SUBJECT: ADDENDUM TO ORNL CF-61-2-46,  
MOLTEN-SALT REACTOR EXPERIMENT  
PRELIMINARY HAZARDS REPORT

ADDENDUM TO ORNL CF-61-2-46,  
MOLTEN-SALT REACTOR EXPERIMENT PRELIMINARY HAZARDS REPORT

Since the "MSRE Preliminary Hazards Report" was written (February 1961), several changes have been made in the MSRE design, and additional information has been requested by the AEC Division of Reactor Development. It is the purpose of this Addendum to up-date and correct the original report and to provide the additional information.

Fig. 14B. Vertical Section-Poison Control Rod.

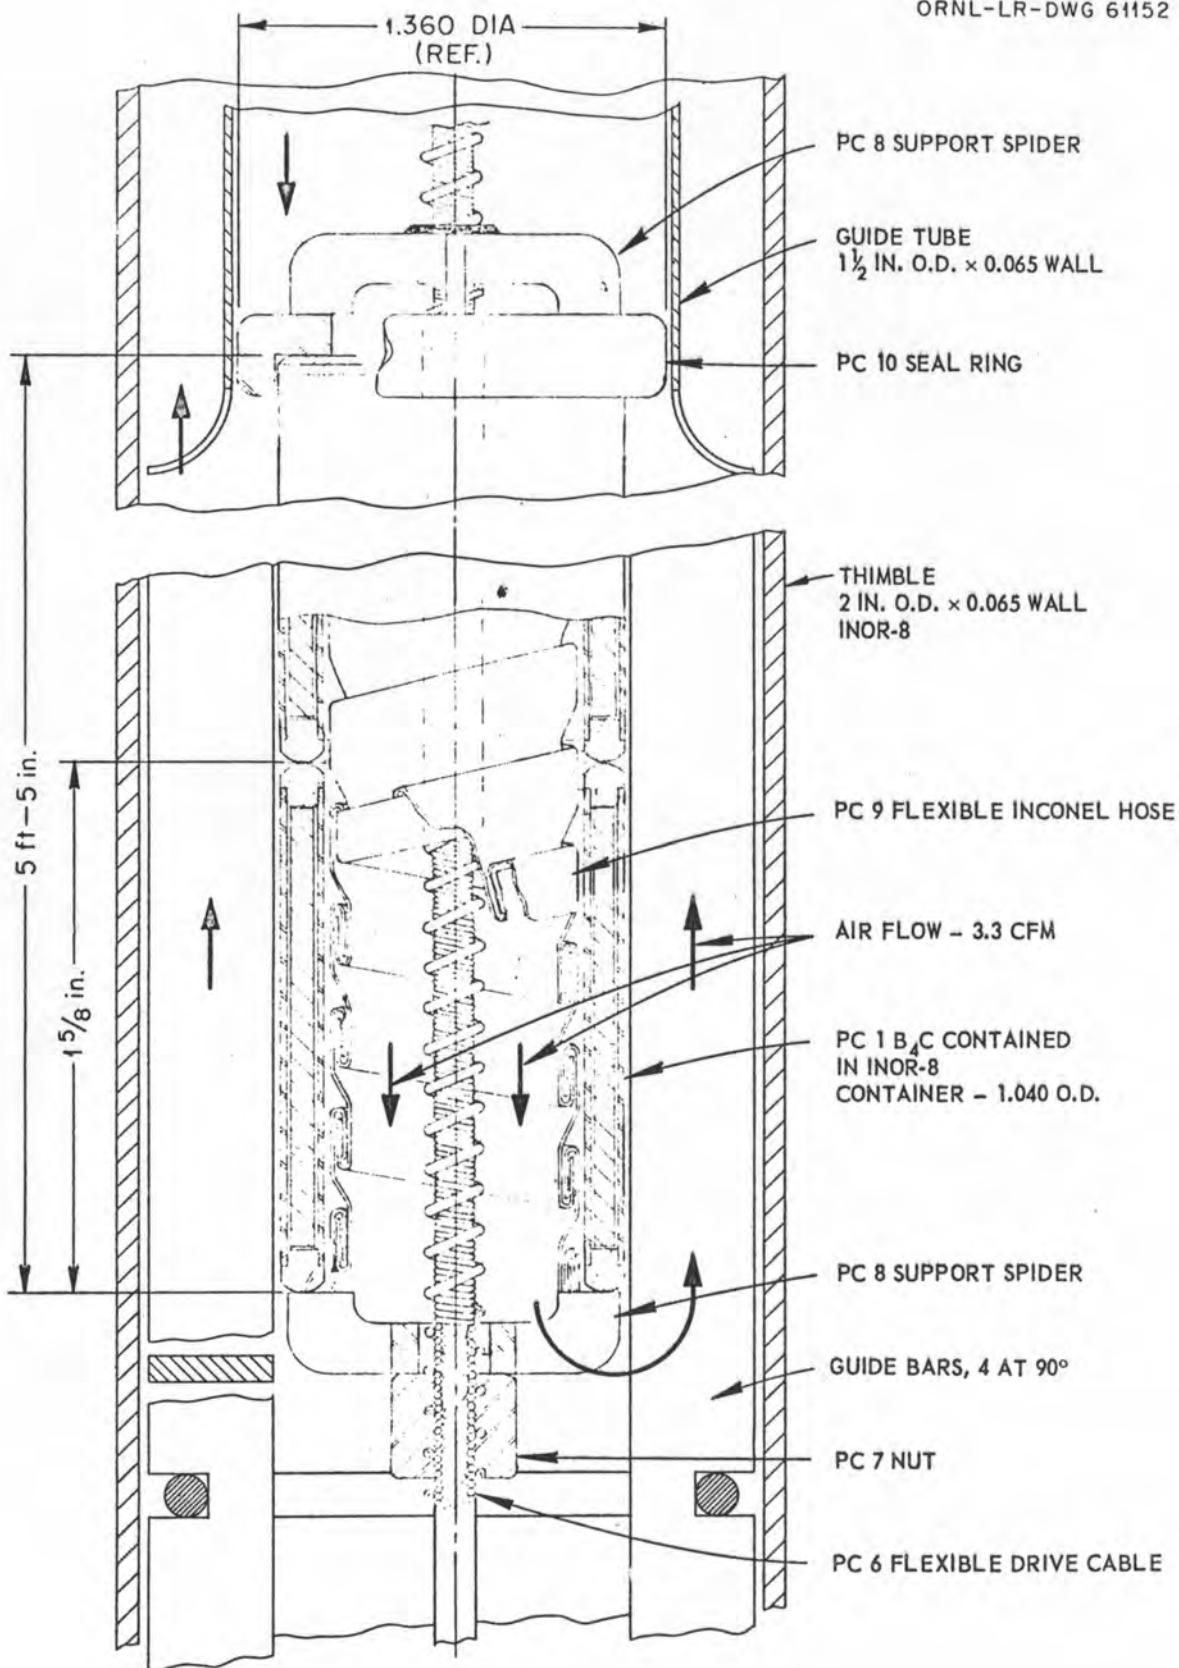
Figure 14-B is a vertical section through a control rod. In essence, the rod is a hollow, contained cylinder of natural boron carbide,  $B_4C$  (19%  $B^{10}$ ). The outside diameter of the  $B_4C$  cylinder is 0.990. The cylinder is formed by stacking a series of small cylindrical sections (Pc. 1, Fig. 14-B), each clad with INOR and having an overall length of 1.625 in. This construction provides a degree of articulation. The resulting limited flexibility greatly reduces problems associated with guide-tube tolerances and differential expansions in both tube and rod which are a consequence of radial flux and temperature gradients. The flexible Inconel hose (Pc. 9, Fig. 14-B) centers and retains the individual cylinders comprising the stack. The slight misalignment between individual cylinders which can result from the nominal 0.020 in. radial clearance between the hose and absorbing cylinders will not affect the operation of the rod.

A flexible cable (Pc. 6), to which has been added a coarse pitch spiral of larger wire, supports and drives the rod. The wire wrap is used as gear teeth and the flexible cable becomes, functionally, a flexible rack. This flexibility allows the drive mechanism to be located on top of the thermal shield instead of the area immediately over the reactor vessel.

The assembly operates inside a 2-in. outside-diameter INOR-8 thimble which penetrates the core. The thimbles for the three rods and the graphite sample are part of a larger assembly, Fig. 14-C, which is centrally mounted on top of the reactor vessel. The three control rods and the graphite sample assembly are incorporated into a flanged module which is bolted to the reactor vessel. Containment is effected by a metal "O" ring and an annular frozen salt seal having an effective length

Fig. 14(Rev.). MSRE Neutron Chamber Arrangement.

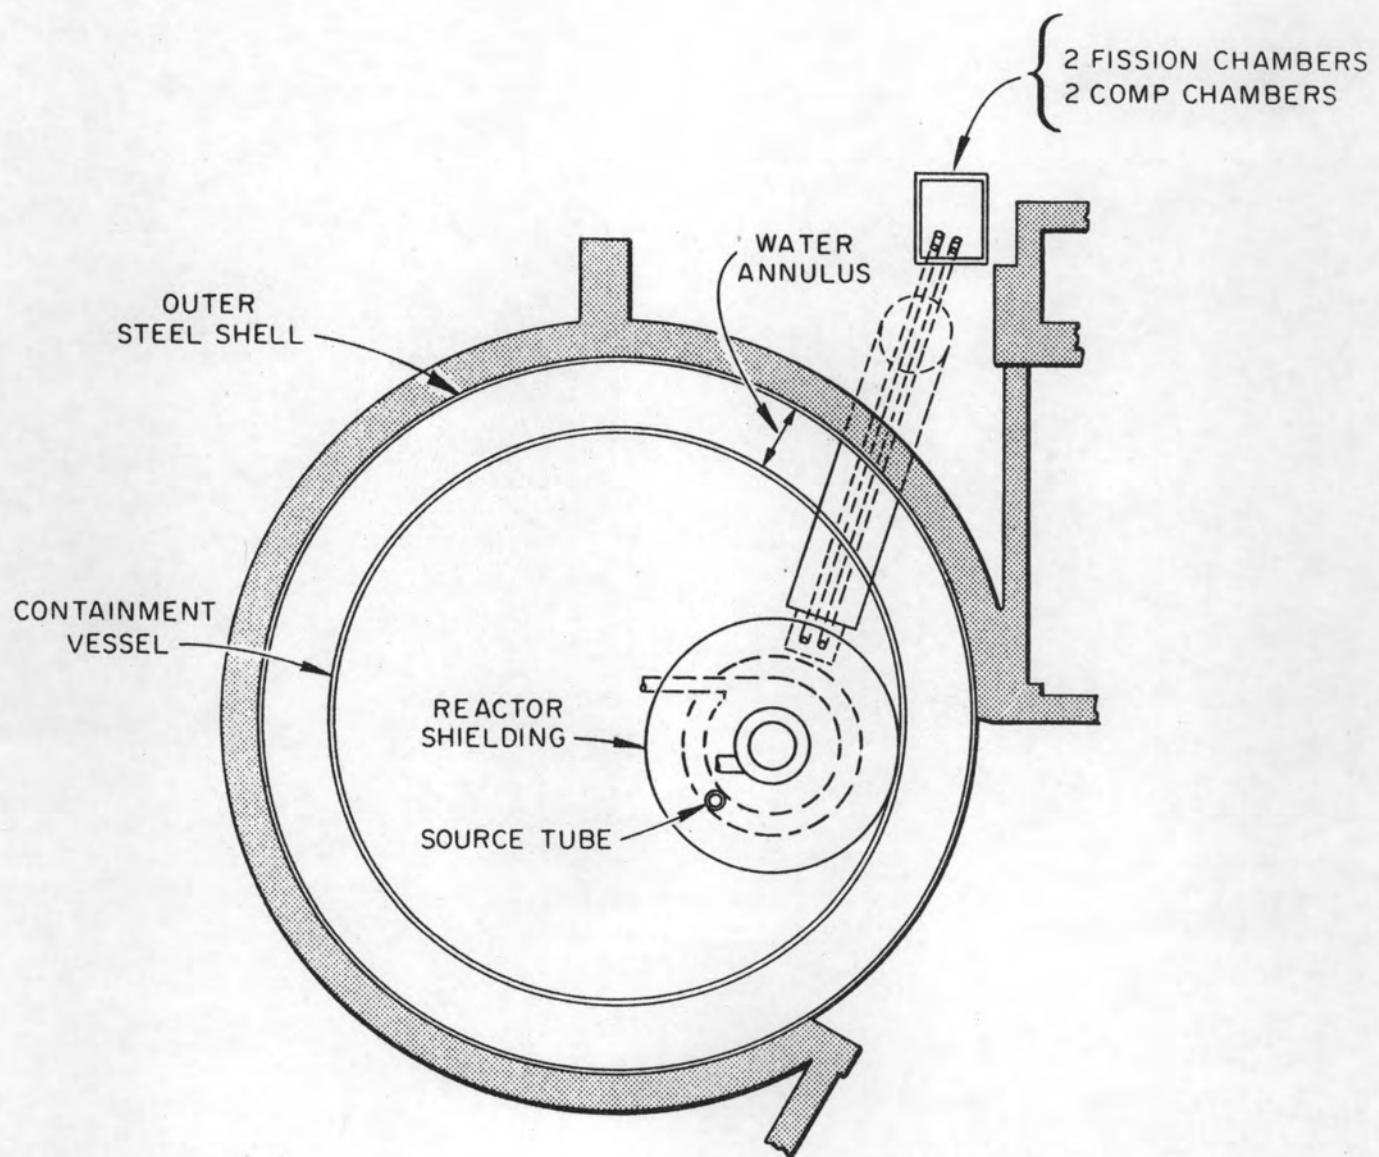
Since the publication of ORNL CF-61-2-46 (refer to Fig. 14, p 40), the nuclear instrumentation has been altered by reducing the number of penetrations from three to one, Fig. 14R. The large southeasterly water-filled penetration which houses four chambers is retained. The chamber complement will be two fission chambers and two compensated ion chambers. These will provide coverage over the full range of reactor operation and will provide the necessary input signals of reactor level and period.

This reduction in both the number and location of nuclear input channels does not compromise ultimate safety which, in the MSRE, is not vested in the control-rod system.
